Access Compliance Report

Public Rights-of-Way

Intersection ID: 30220	Main Street: PATRICIA_RYAN_DR	Cross Street: MARGARET_KELLY_CT	Location:	N
ADA ID: 1AC6BDD373C9	Ramp Type: PerpDiag	Initial Pass/Fail: Fail	Overall Compliance: No	Severity Score: 8.75
Codes/Mitigation Info/Possible Solution		Field Measurements/Component Compliance

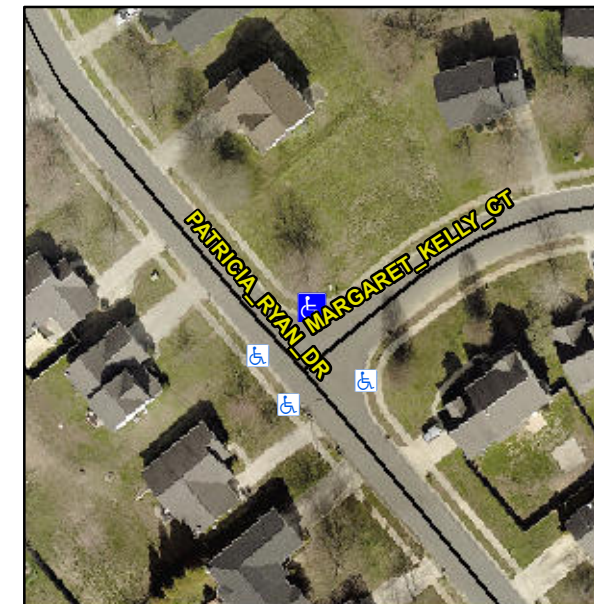
Remove & Replace Curb Ramp With Two New Directional Ramps or Equivalent.

Not Found, R304.5.1
